ROAD DESIGN MANUAL REVISIONS January, 2017

REINFORCED SOIL SLOPE (RSS) STANDARD

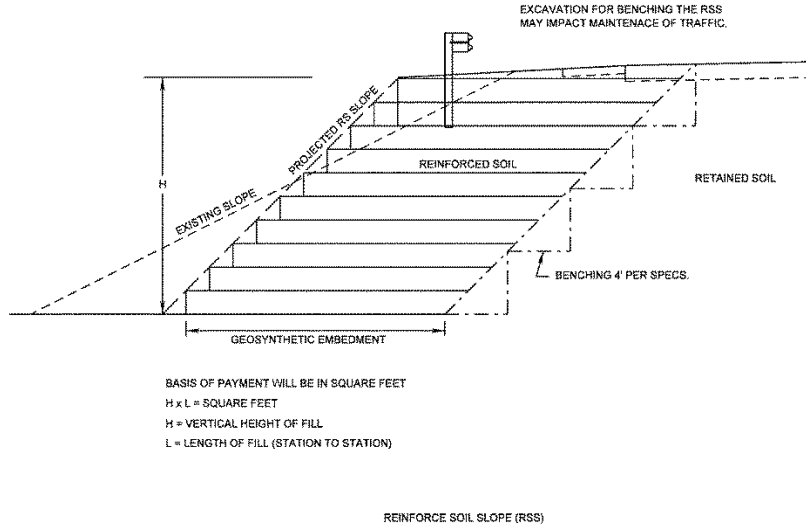
- Page 2E-21 thru 23 – Added the following language;
RETAINING STRUCTURES

RSS may be used as an alternative to purchasing additional right of way or the construction of a retaining wall. In general, RSS may be less expensive when a wall or additional right of way would otherwise be necessary.

This standard design is applicable when slopes are designed to be steeper than 2.0H:1.0V but no steeper than 0.5H:1.0V, and when the foundation conditions and backfill meets the criteria in the standard. Aesthetics and maintenance should be considered as part of the decision.

The design engineer may use the RSS standard design when the following conditions are met and approved by the District Materials Engineer:

The engineer shall specify on the roadway drawings the following:

- 1) *In plan view, the top of slope and toe of slope.*
- 2) *Slope:*
 - *1/2H:1V*
 - *1H:1V*
 - *1½H:1V*
- 3) *Backfill Type:*
 - *A (Select Material)*
 - *B (On-site or Imported Soils)*

- 4) *Case:*
- 1 (Soft soil and maximum groundwater level at depths equal to or greater than slope height)
 - 2 (Soft soil at depths equal to or greater than reinforcement length and maximum groundwater level at toe of slope)

The maximum height for the RSS shall be 35 feet for Type A and 20 feet for Type B.

To reduce the likelihood of an error, the same backfill type and foundation case shall be specified throughout the entire slope, unless there are compelling reasons to differentiate between the two.

If the embankment and RSS are to be simultaneously constructed, consideration may be given to eliminating the internal RSS drainage (geocomposite and outlet drains).

The engineer shall determine the total square footage of the RSS based on vertical projection of the slope face (top of slope to toe of slope) for the specified slope ratio and payment will be made based on that area.
